# Four Design (Pvt.) Ltd.

8<sup>th</sup> February 2021

# Buildings Information

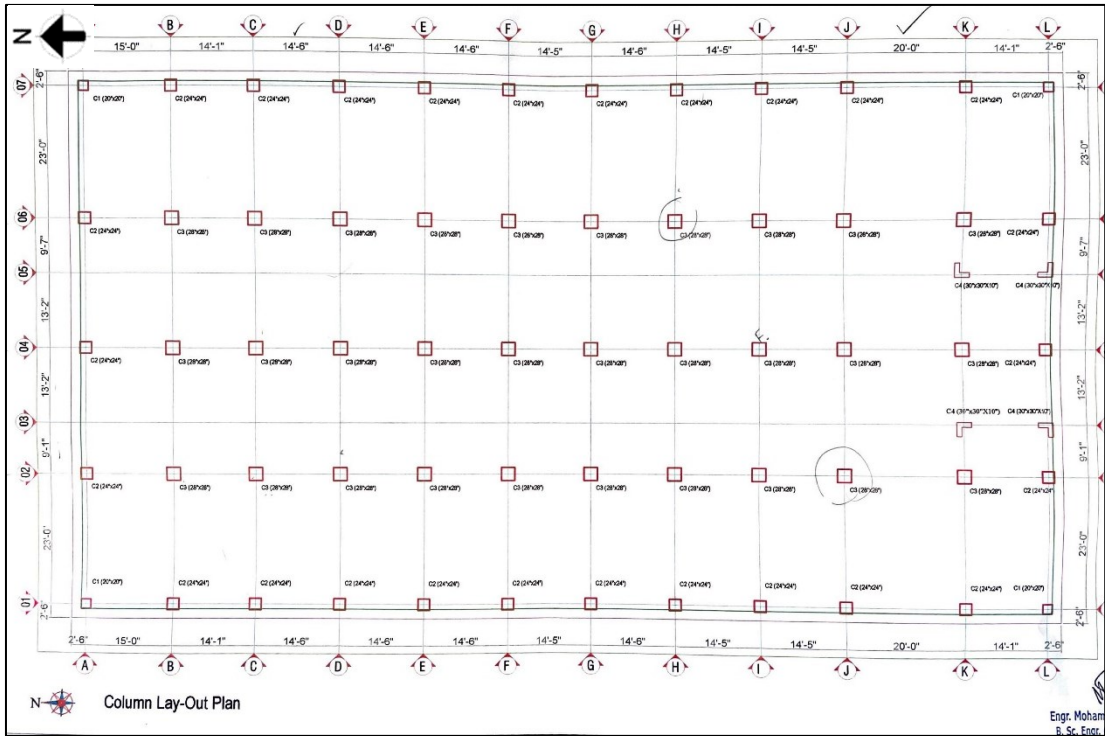
**Column to be stressed exceeds normal design limit**

Cursory calculation indicates that columns are stressed above normal design limit considering prepared live load plan and minimum concrete strength based on aggregate type. Factory engineer is required to review design, load & column stress.

Item No.	Observation	Recommended Action Plan	Recommended Timeline
01	Column to be stressed exceeds normal design limit. (Garments Building)	Factory Engineer to review design, loads and columns stresses.	6-weeks
02	Column to be stressed exceeds normal design limit. (Garments Building)	Verify in situ concrete stresses either by 100mm dia. cores or existing cylinder strength data or [100mm dia. cores from 4 columns].	6-weeks
03	Column to be stressed exceeds normal design limit. (Garments Building)	Factory Engineer to prepare design report as per BNBC (part 6; Article 1.9.1) by reviewing design, loads and capacity of structural members	6-weeks
04	Column to be stressed exceeds normal design limit. (Garments Building)	Produce and actively manage a loading plan for all floor plates within the factory giving consideration to floor capacity and column capacity.	6-weeks
05	Column to be stressed exceeds normal design limit. (Garments Building)	Carry out remedial works where necessary.	6-months
